**ADDENDUM NO. 01**

**Dated: Jan. 13, 2023**

**Project No.: 16640E-01-02**

**Description: Ziehler Playground**

**E-1.1**

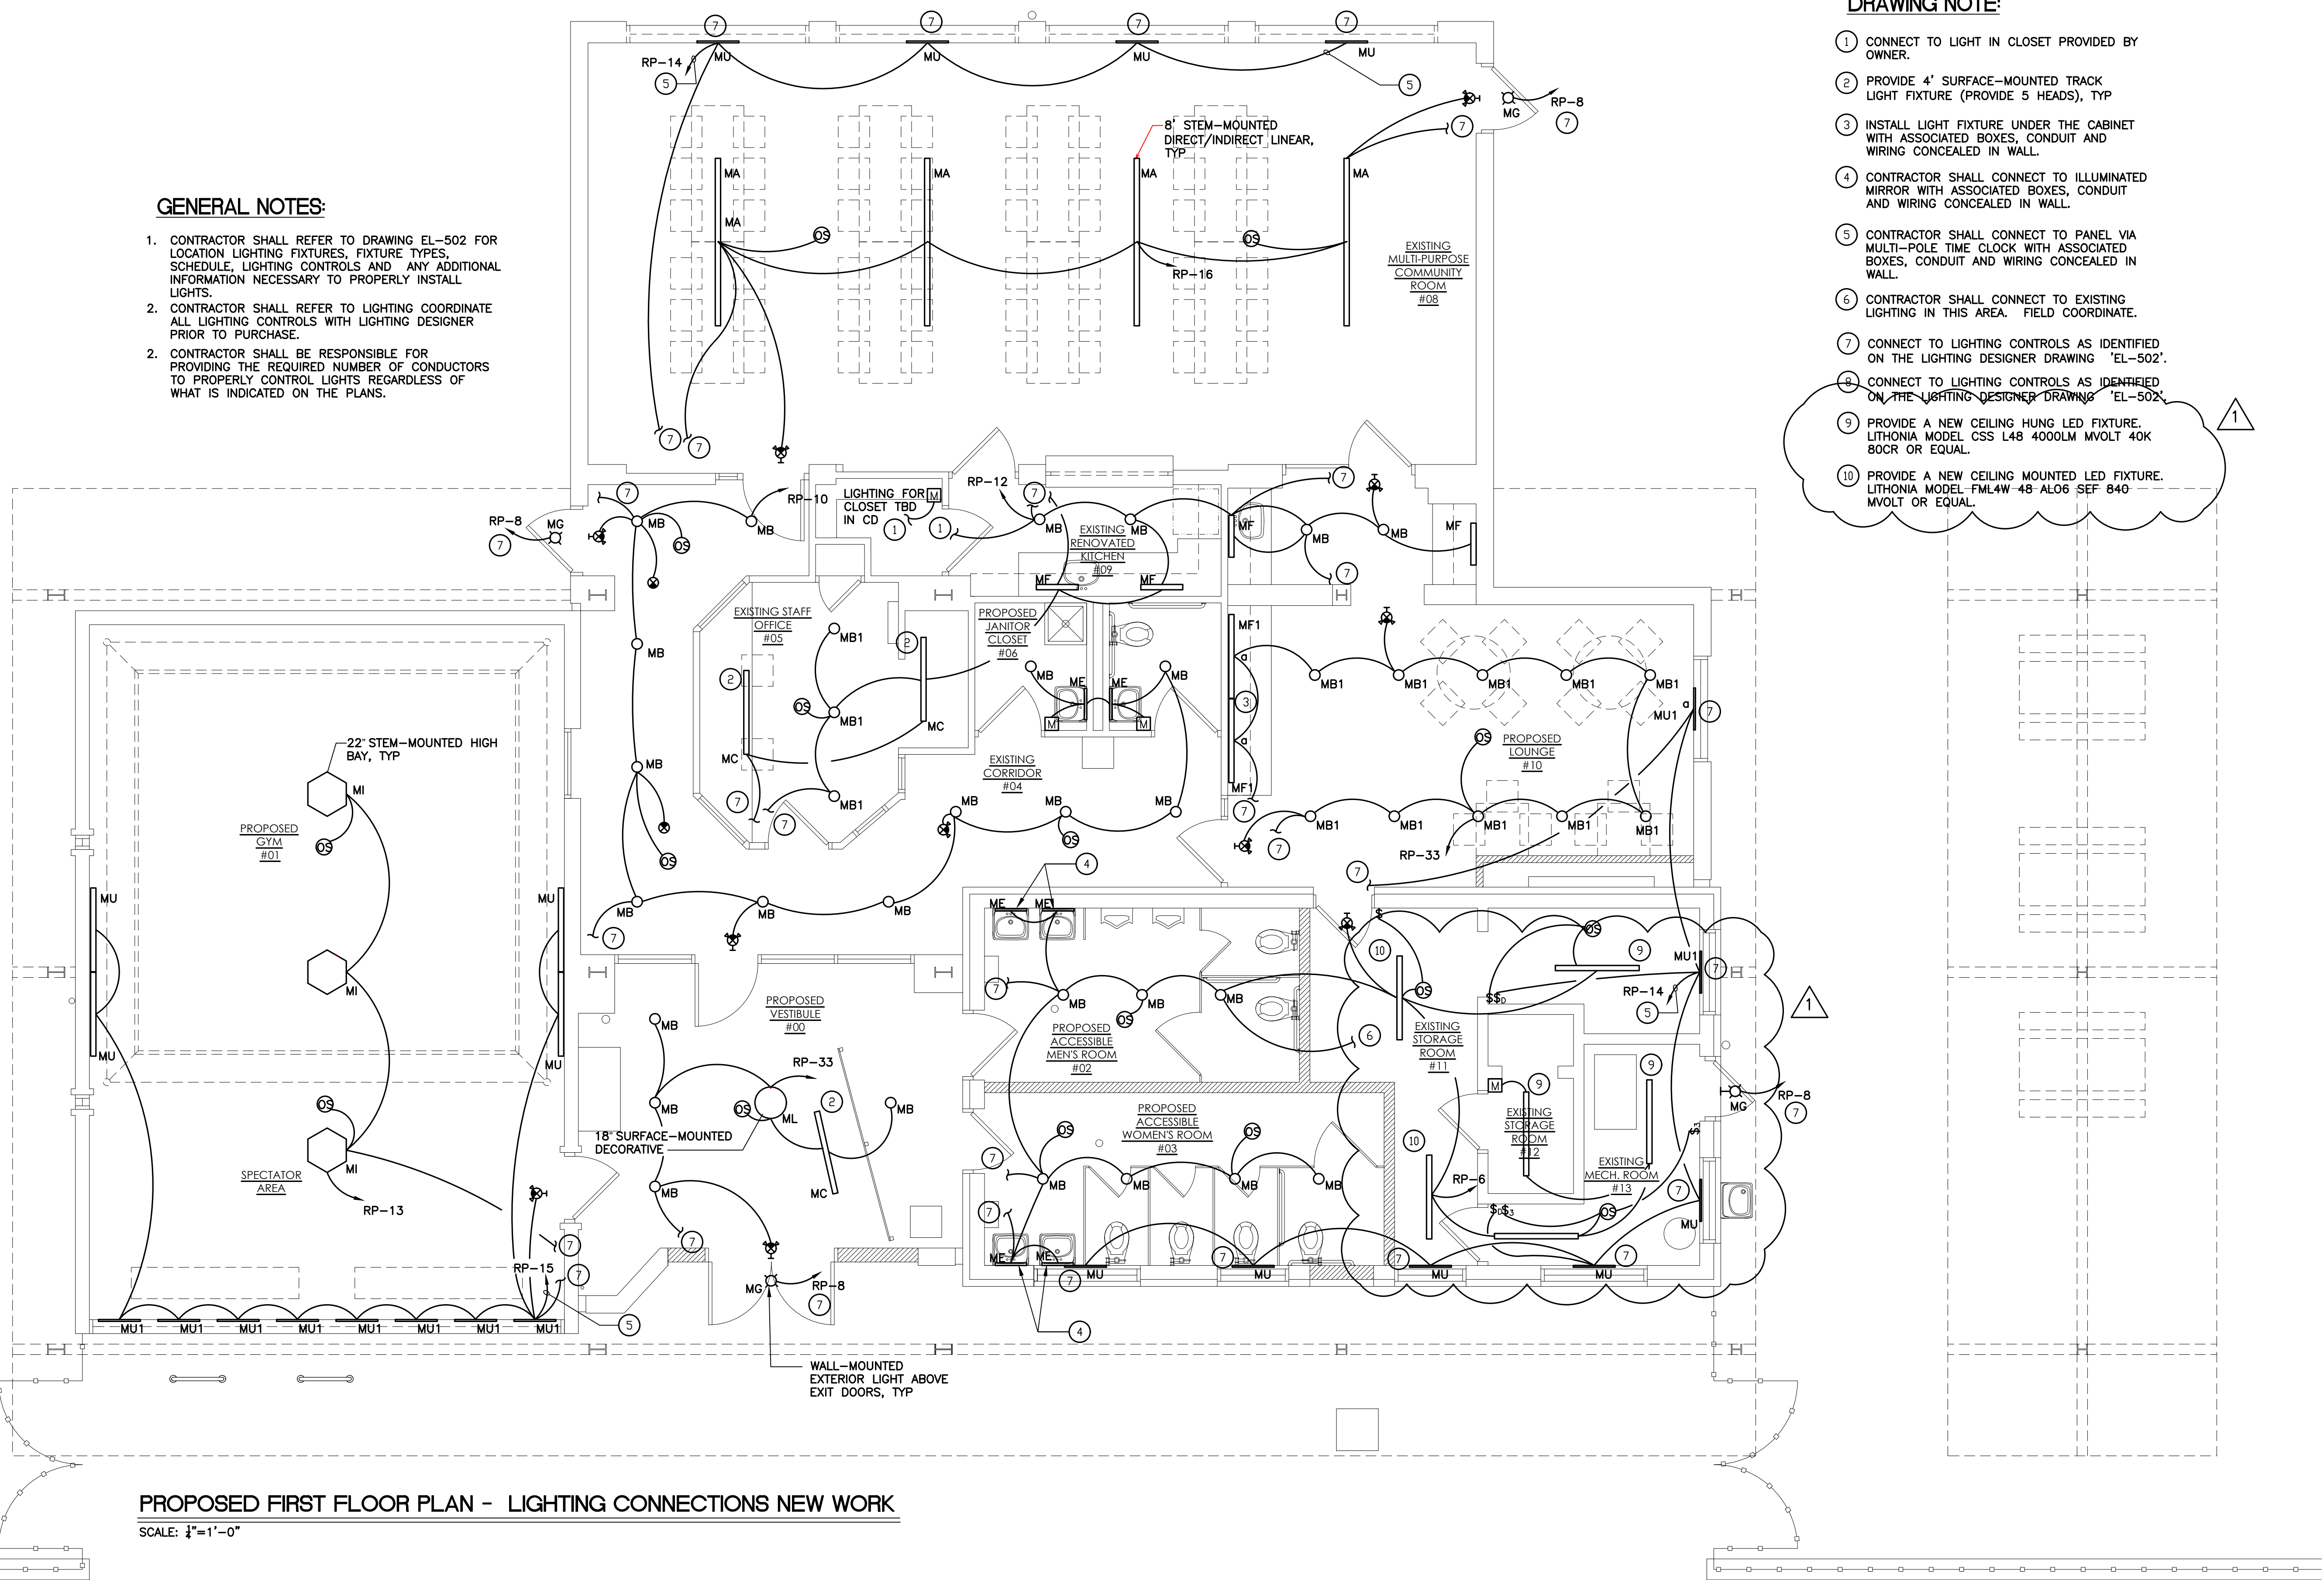
7. Drawing E-1.1: What is the fixture type for Storage Rooms 11, 12 and 13?

**ANSWER: Lithonia Model CSS L48 4000LM MVOLT 40K 80CR.**

- CONNECT TO LIGHTING CONTROLS AS IDENTIFIED ON THE LIGHTING DESIGNER DRAWING 'EL-502'.
- PROVIDE A NEW CEILING HUNG LED FIXTURE. LITHONIA MODEL CSS L48 4000LM MVOLT 40K 80CR OR EQUAL.
